DESCRIPTION OF DIFFERENCES

between CURRENT MODEL and NEW MODEL

CURRENT MODEL	NEW MODEL
Name of Appliance :	<u>Center Module</u>	<u>Center Module</u>
Model No. :	<u>WX-CC412</u>	<u>WX-CC412A</u>
FCC ID :	<u>ACJ9TAWX-CC412</u>	<u>ACJ9TAWX-CC412A</u>
IC ID :	<u>216A-WXCC412</u>	<u>216A-WXCC412A</u>

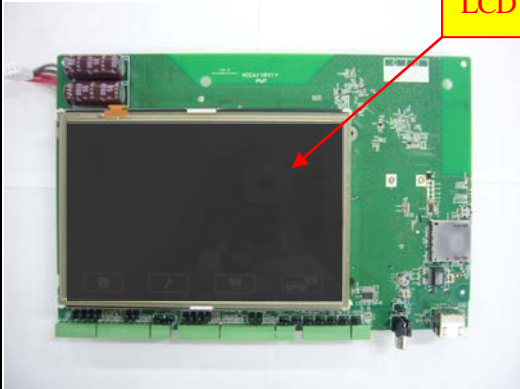
CURRENT MODEL WX-CC412	NEW MODEL WX-CC412A
LCD Display	<p>Manufacturer: LG Display Co., Ltd. Type: LB070WV4 LCD Type: TFT</p> 	<p>Manufacturer: Shanghai Tianma Micro-Electronics Co. Ltd. Type: TM070RDHG20 LCD Type: TFT</p> 
LCD Display Driver/ RF Unit/ Antenna
